Re: Rapiscan AIT System Radiation Survey Reporting

Rapiscan	Secure 1000 Radiation Emission Measurement	FORM R-0646-1 (Single Pose)
----------	---	--------------------------------

R-0646-1 Addendum (Documentation Errors)

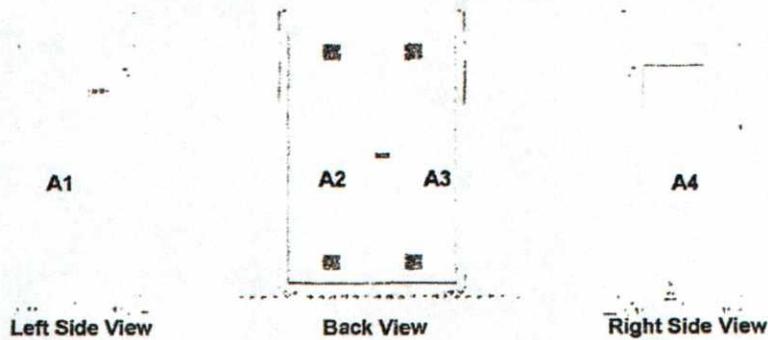
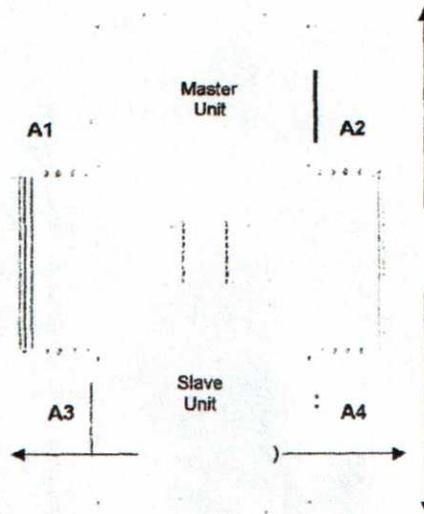
1. Technician indicated scan time as 7 seconds. Correct scan time is 3 seconds.
2. TABLE 1: Incorrect presentation of data in Column 3 for Measured Exposure. Indicated Measured Exposure for the Master Unit is 9.9 uR, which is higher than expected. A probable source of error may be due to the Technician positioning the meter too close to the unit when obtaining data. While the value indicated is approximate to the Manufacturer's administrative limit, it is well below the regulatory limit.
3. TABLE 2: Incorrect presentation of data in Column 3 for Measured Exposure and in Column 6 for Dose Equivalent. Technician seems to have transposed values.
4. Technician did not initial pass or fail check box.

The service technician should attend refresher training as soon as possible with an emphasis on measurement methodology.

The corrected data indicates this system was operating within expected parameters. No re-survey is required for this system.
